**SUBJECT: Comment Response Letter – Bent Grass Residential Filing No. 2 (SF-19-014)**

Please see the following responses in ***bold and italics*** for the 1<sup>st</sup> review of Bent Grass Residential Filing No. 2.

ON-SITE STORM - 4  
STA: 1+00 - 2+47.83  
SCALE: H: 1"=40' V: 1"=10'

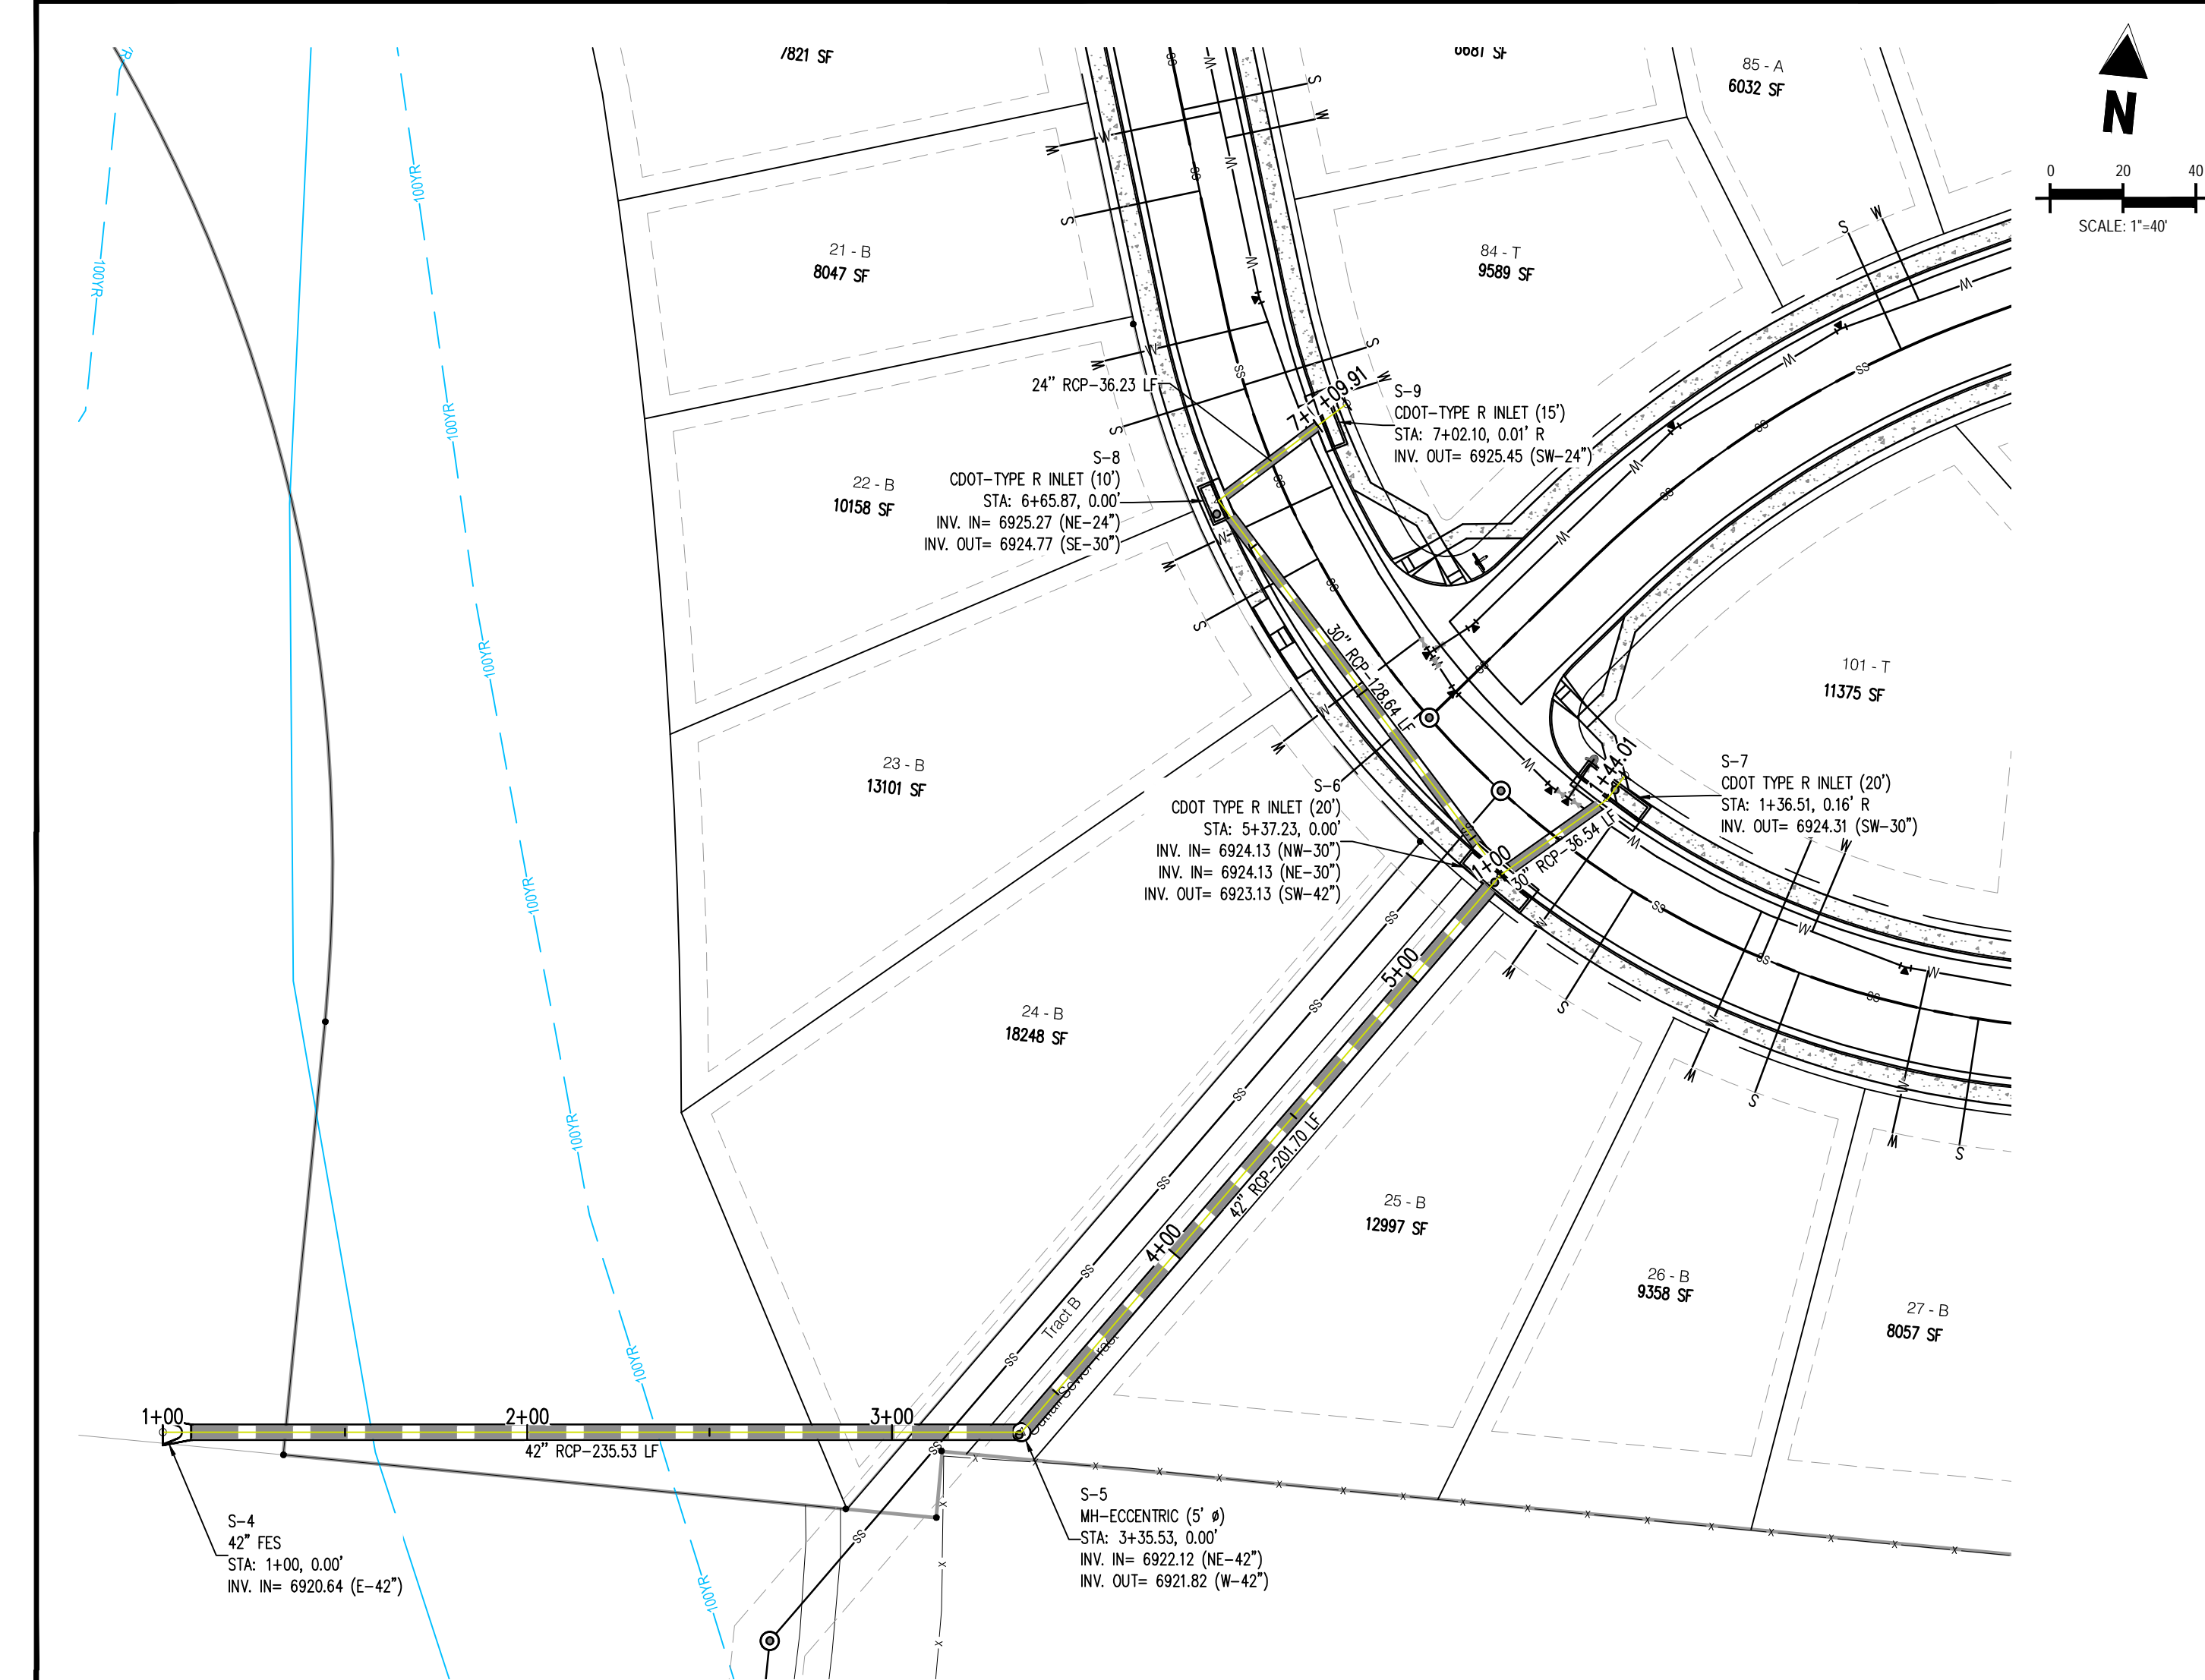
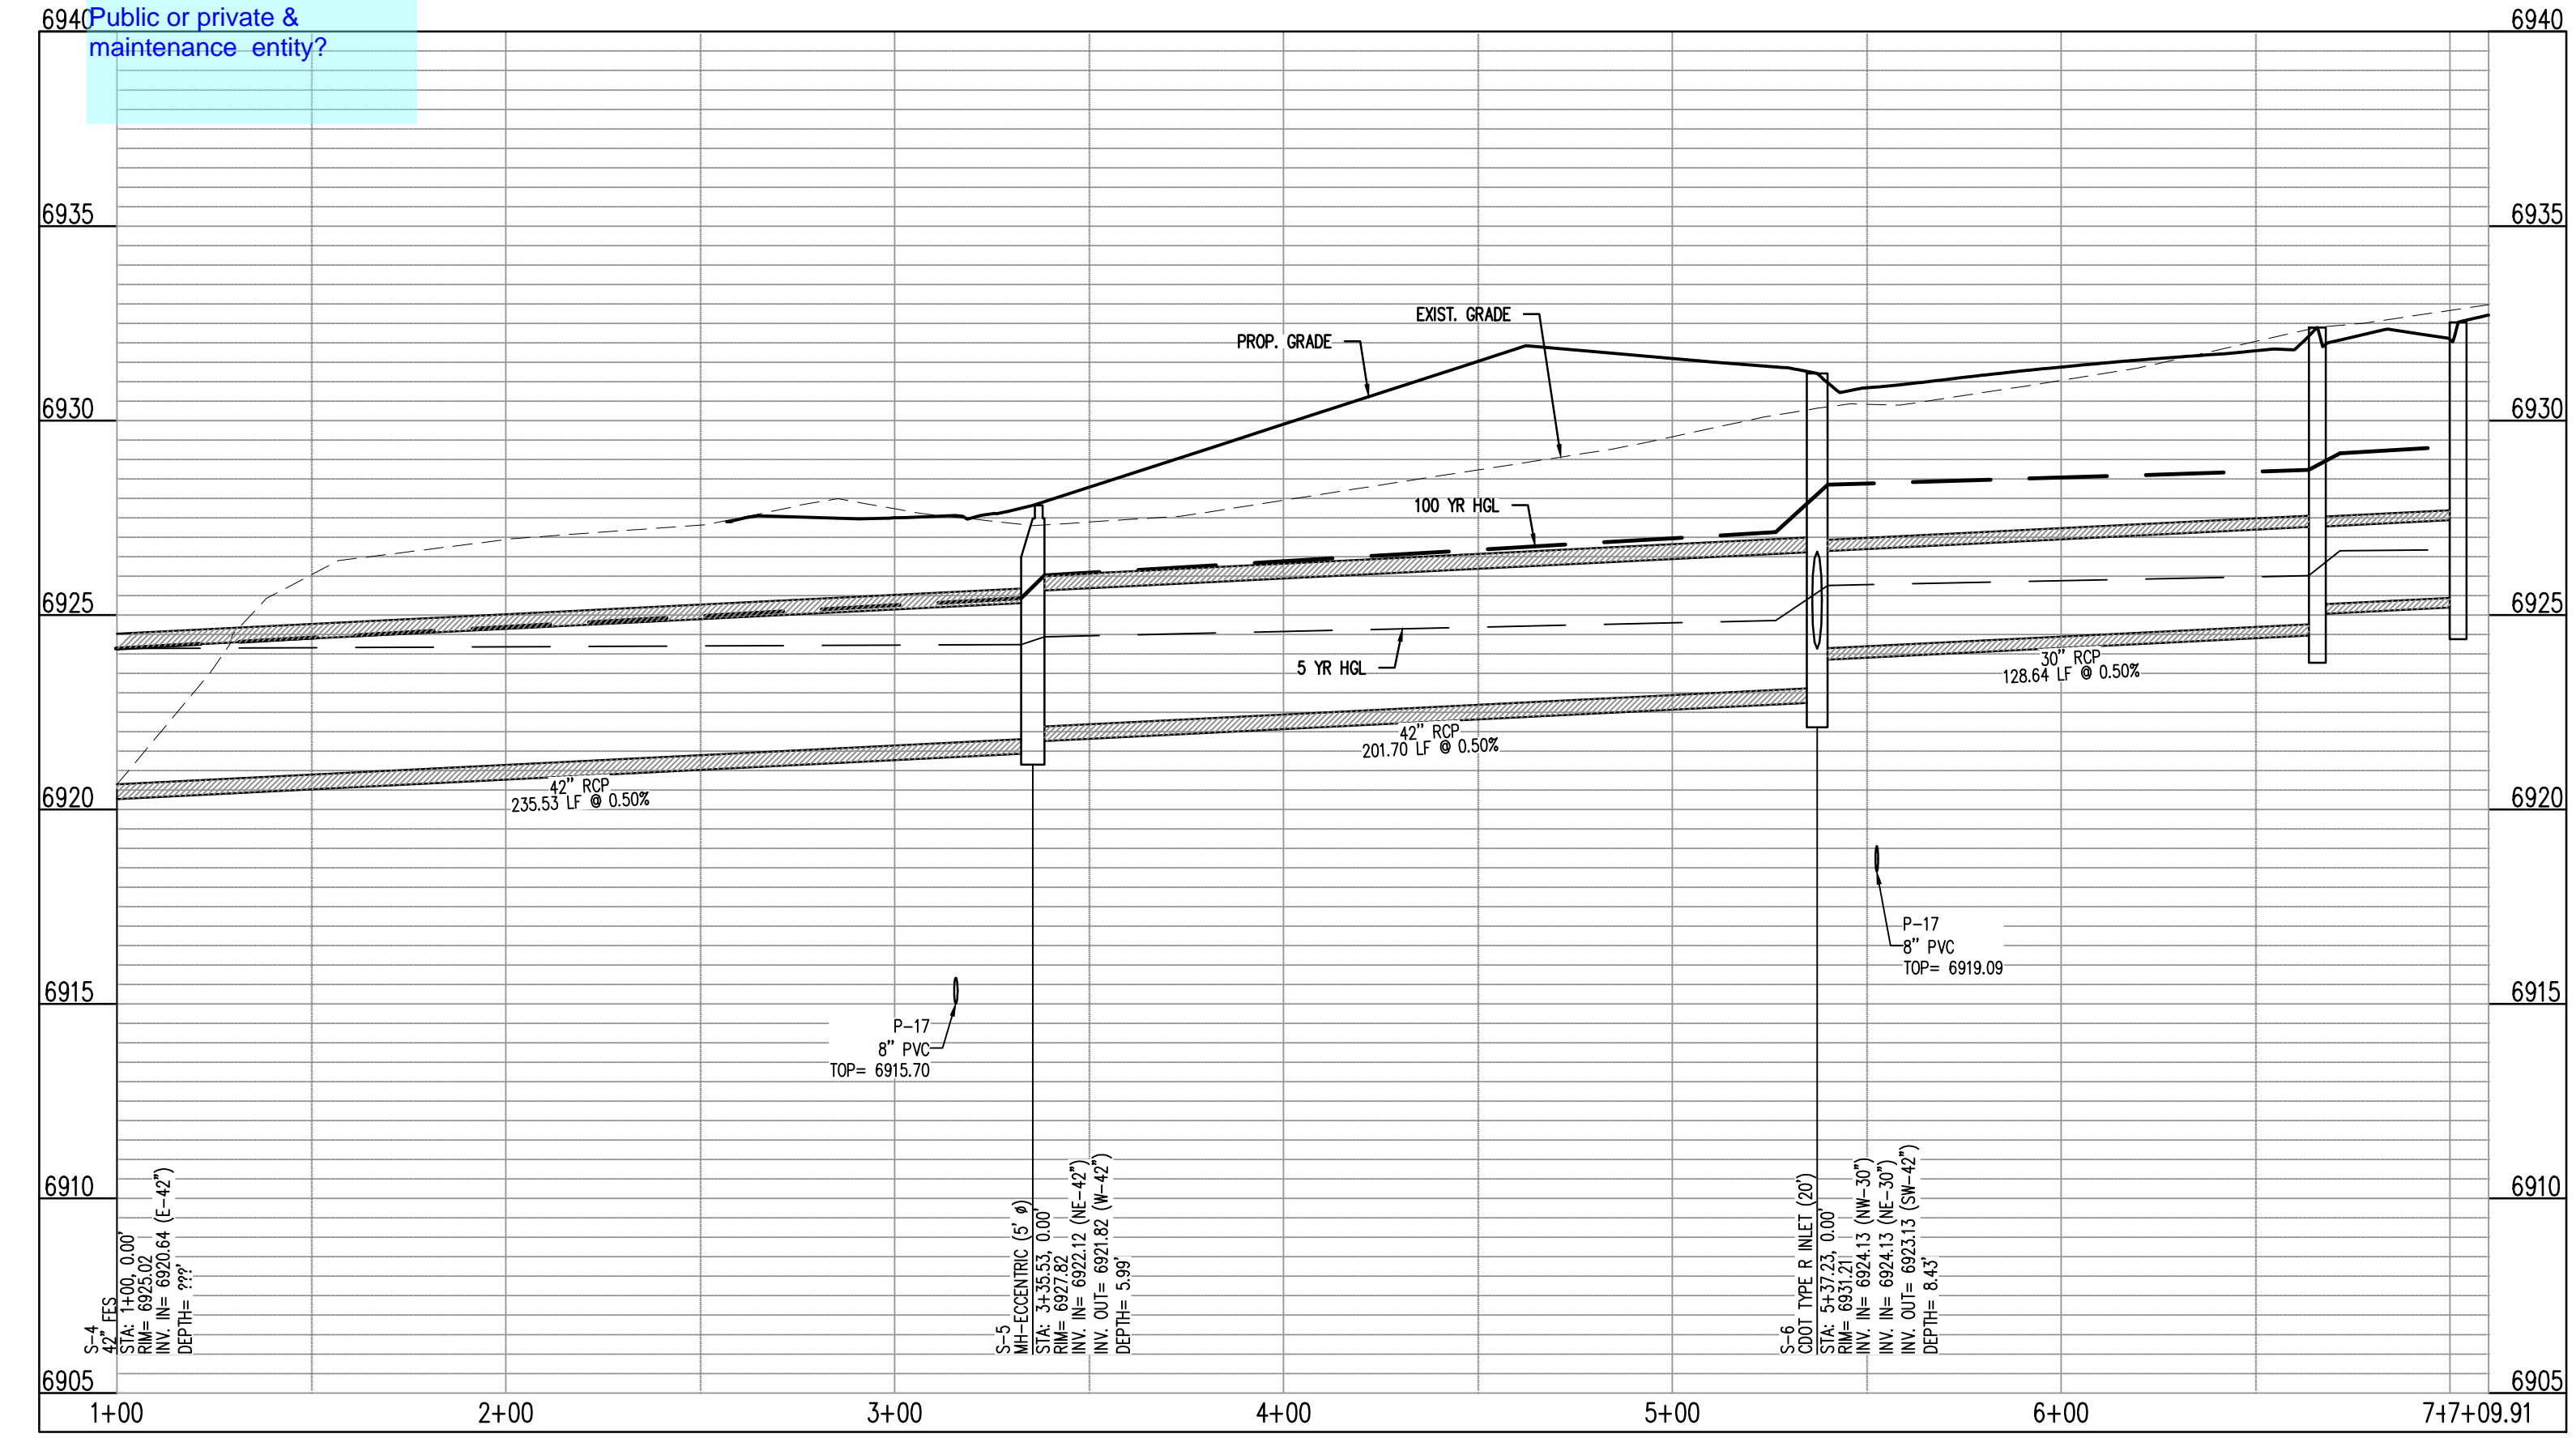
Below is a general comment about all the outfalls into the channel.

Show the outfall, Rip rap dissipater? Property lines? Where the bottom of the channel is? etc. ? Easements? Public or private & maintenance entity?

Added detail to this sheet and other storm plan sheets. Also see GEC Plans for Rip Rap Dissipater (Storm Pipe Outfall)

THE FORD CT - CL - 50' ROW  
STA: 1+00 - 5+60.99  
SCALE: H: 1"=40' V: 1"=10'

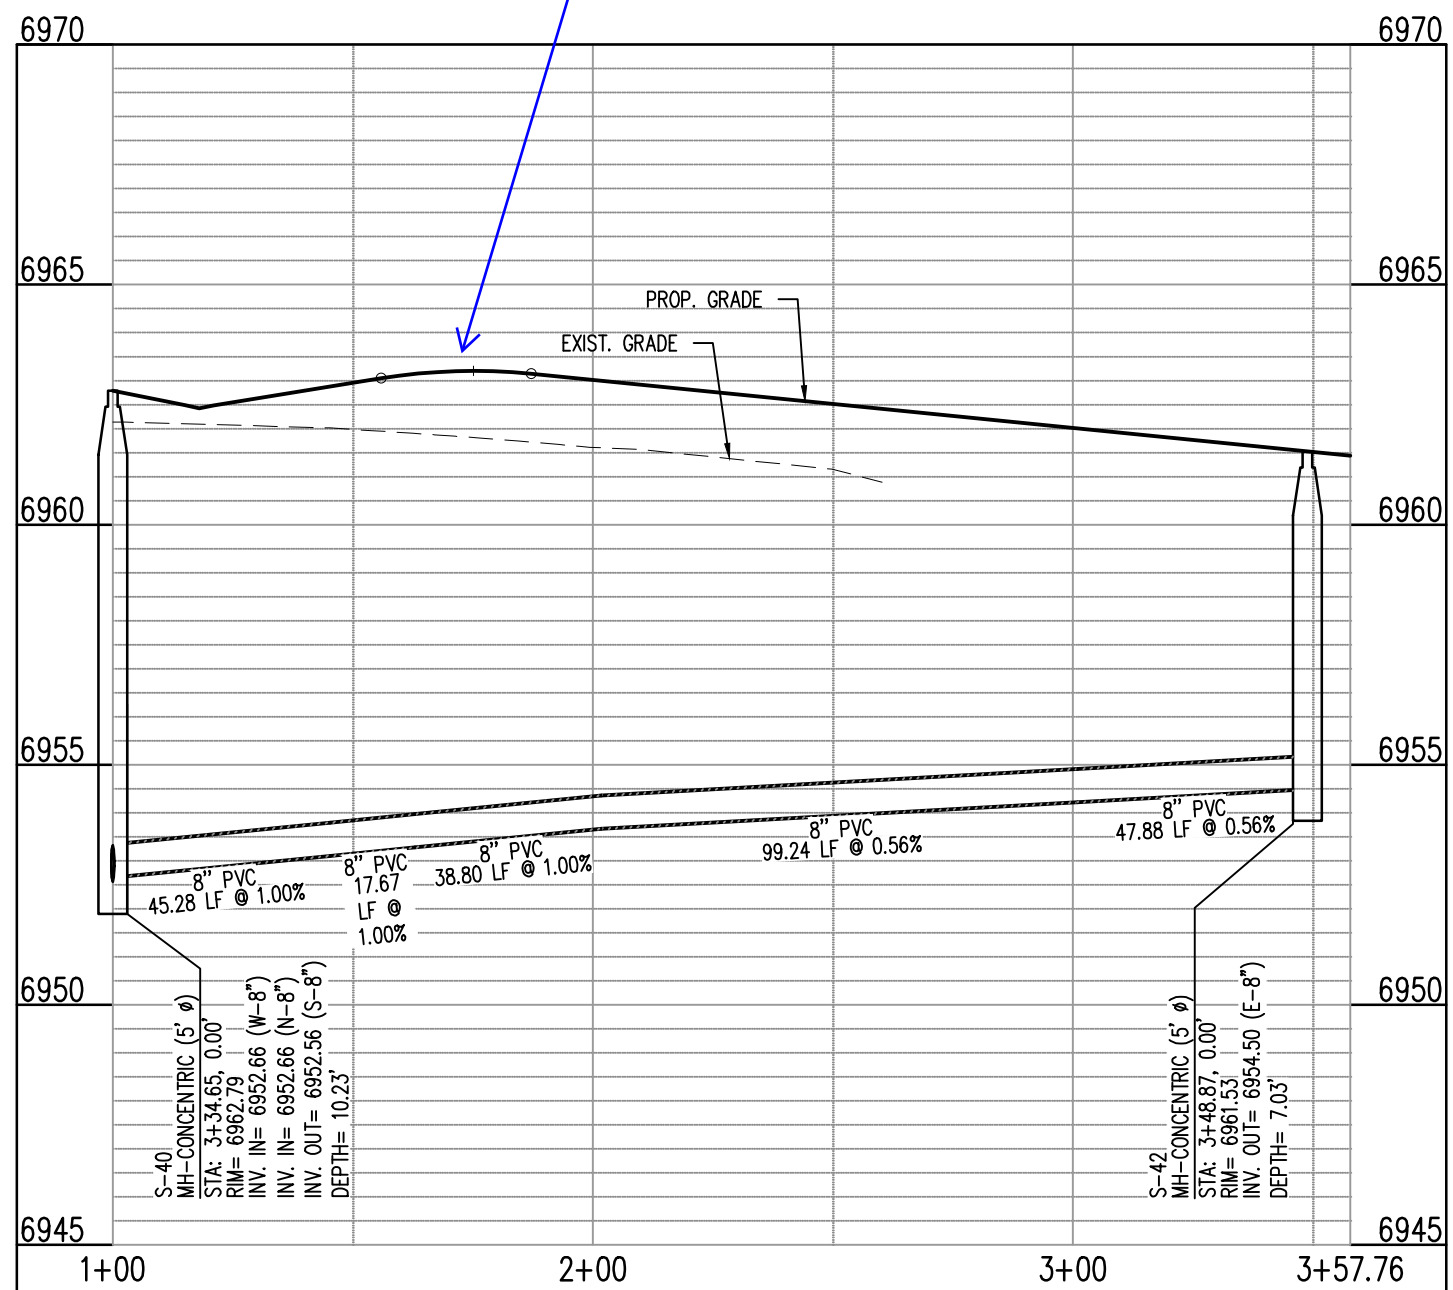
general comment for  
all profiles call out  
vertical curve  
information on the  
profile including K  
value.  
Revised as requested
